EXPEDITED
HISTORIC PRESERVATION COMMISSION STAFF REPORT

Address:	3724 Baltimore St., Takoma Park	Meeting Date:	3/14/18
Resource:	Primary-One Resource Kensington Historic District	Report Date:	3/7/18
Review:	HAWP	Public Notice:	2/28/18
Case Number:	31/06-18C	Tax Credit:	n/a
Applicant:	Adeline Vanderver	Staff:	Dan Bruechert
Proposal:	Accessory Structure Removal

Re: Garage

Photo 4
Sagging hip beam

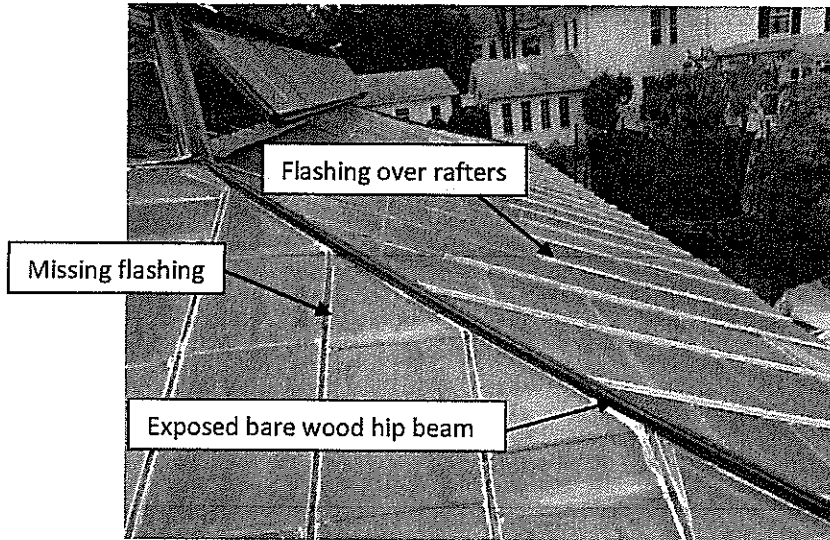
Hip beams are constructed in a similar manner to the rafters except that 3 of the small wood sections are used. All of the hips are exposed to the weather and have sagged significantly and show signs of rot (see photos 4 and 6).

Photo 5
Sagging rafters

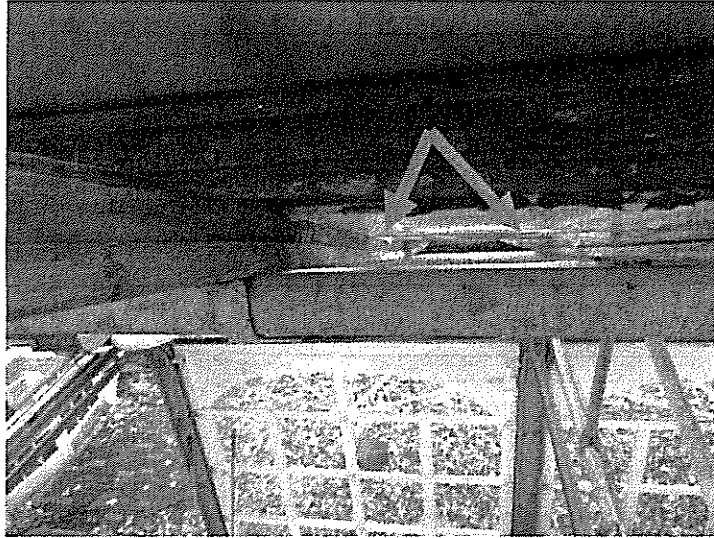
The roof rafters are two 1¾" wide, 2¼" tall wood members set atop one another and spaced 17 inches apart. Each member supports a layer of ¼" thick glass so that there is a sandwich made of two glass panels. The rafters are rabbeted to support the long edges of the glass roofing that sit in between adjacent rafters. It is not known how the glass is held in place. Originally, the tops of the rafters had small lengths of metal flashing that kept rainwater off the wood and out of the glass joint. The majority of those pieces of metal flashing have disappeared (see photo 3) exposing the wood to rainwater and causing rot. Furthermore, the wet conditions have also caused the members to sag (see photo 5).
